ADDENDUM NO. FOUR

PROJECT: Johnson County Recycling Center

PROJECT NUMBER: 23122

DATE OF ADDENDUM: June 5, 2024

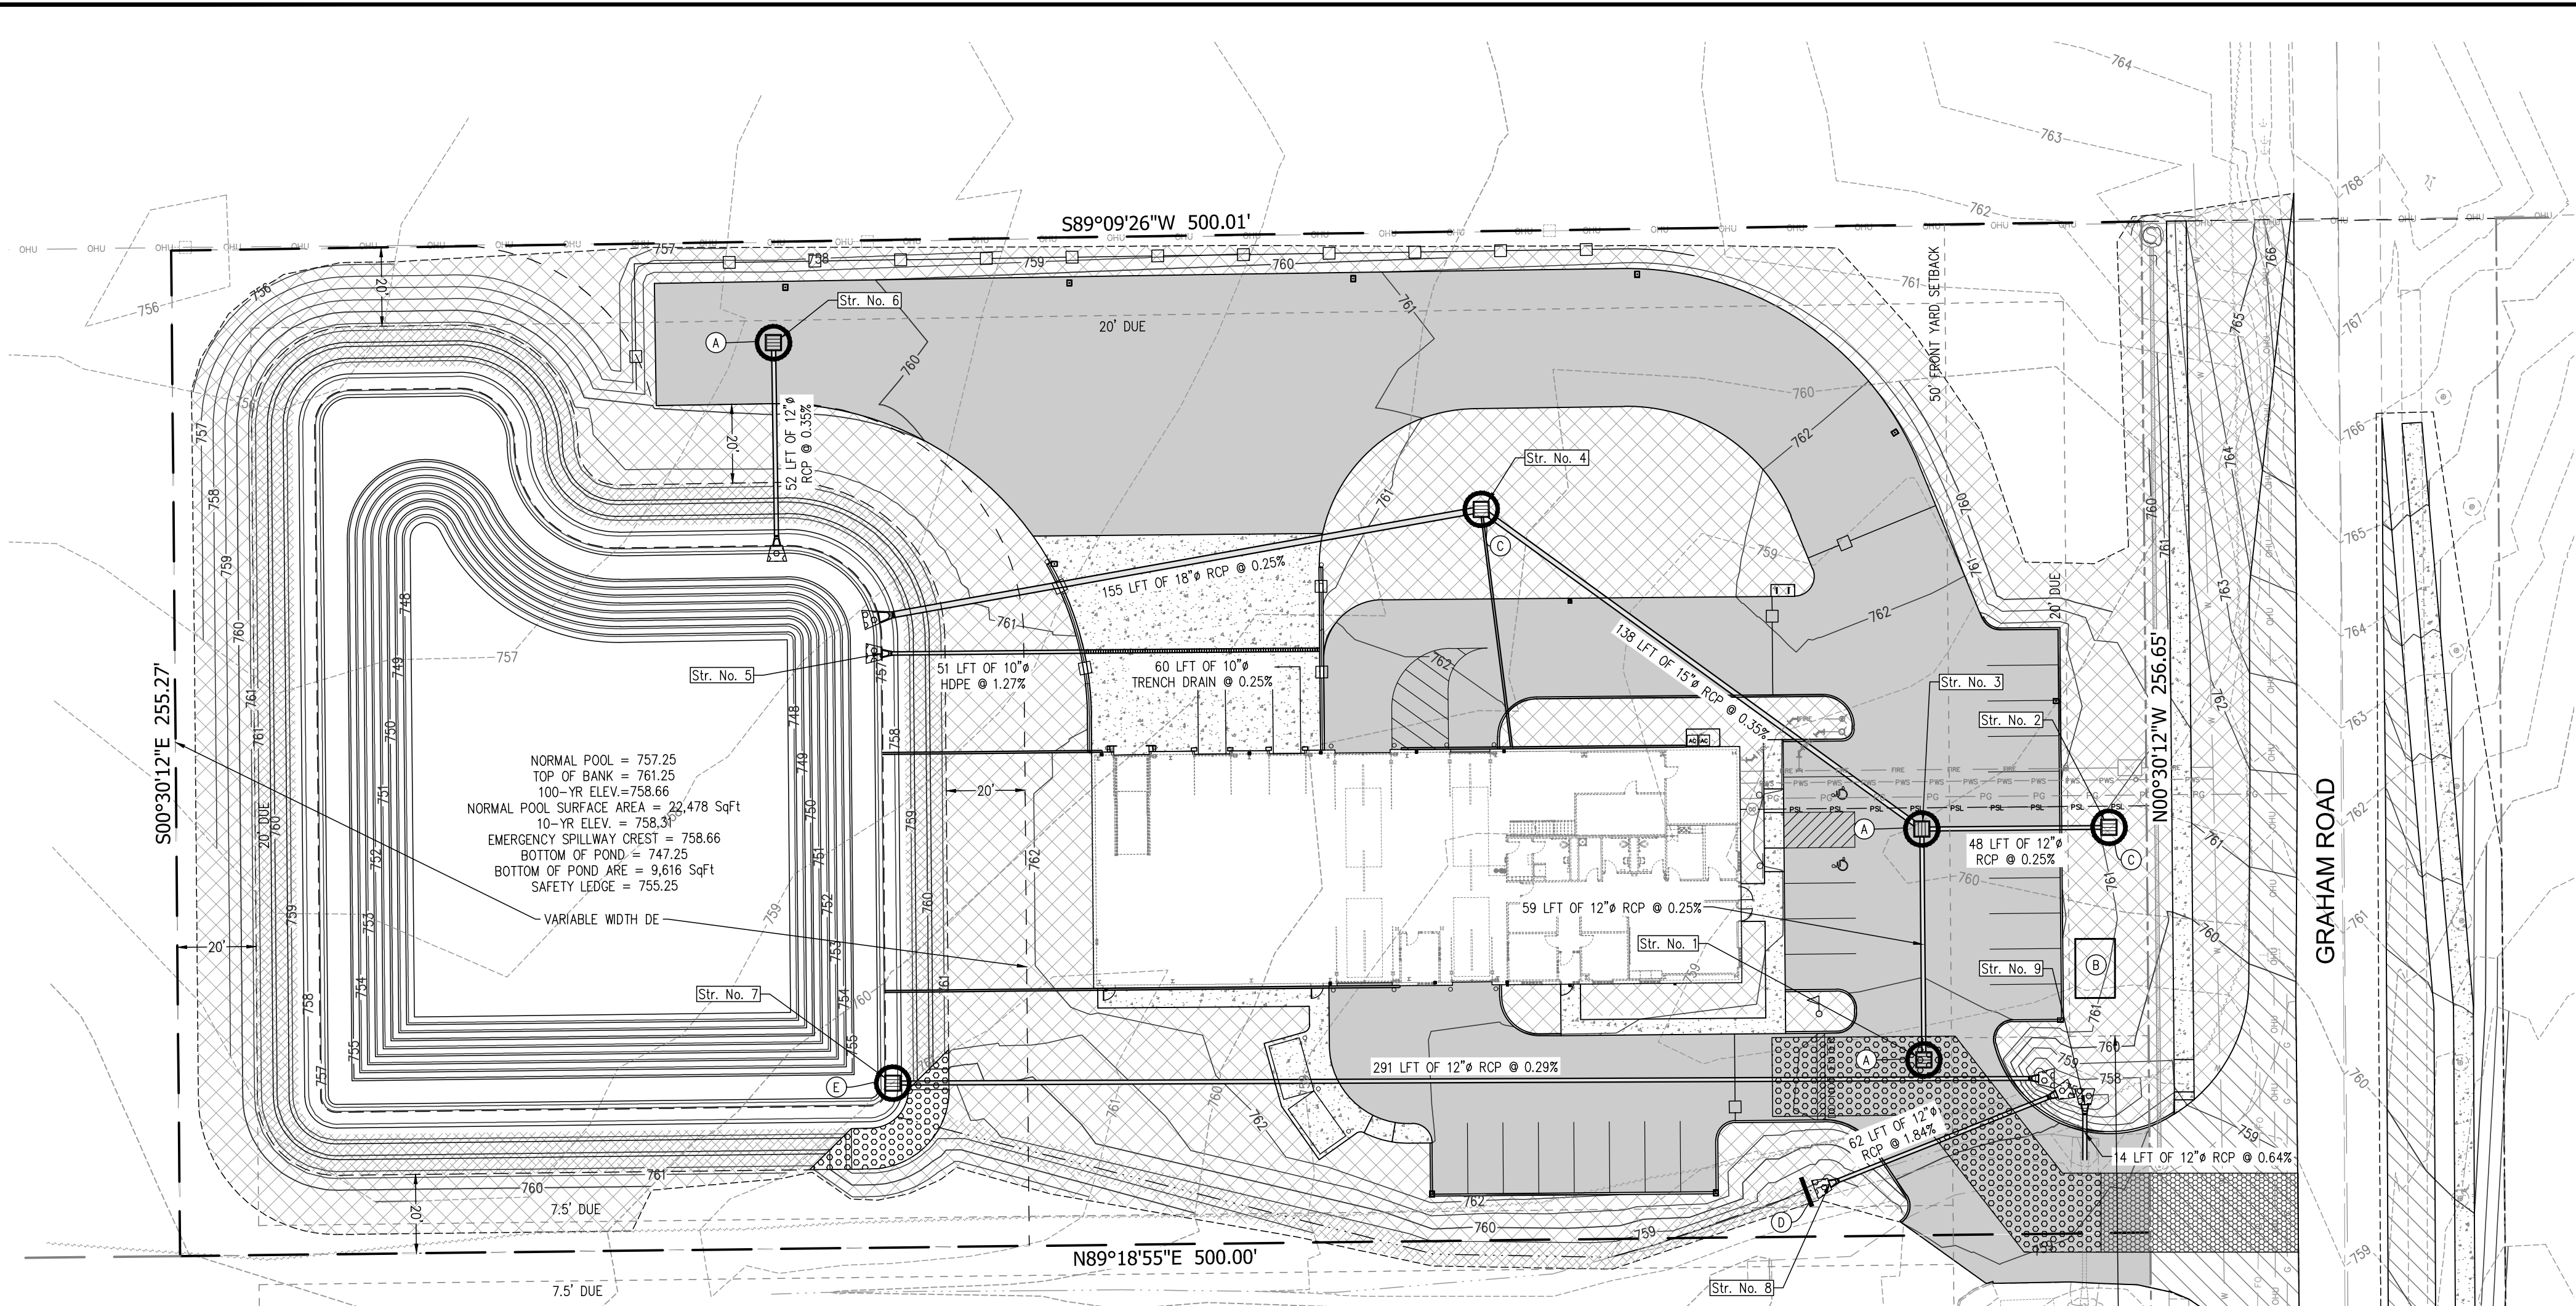
- Sheet 900
 - o Added Erosion Control Blanket along new ditch cut from the pond spillway to the drive culvert
 - o Adjusted limits of construction around the southern portion of the property
- Sheet 901
 - o Adjusted A22 and A23 accordingly with changes to construction limits
- Sheet 1000
 - o Added more information for the retaining wall details including thickness, footing depth, and rebar
- Sheet 1200
 - o Adjusted location of all trees and shrubs. Added callouts for the desired type of tree to be used at each location
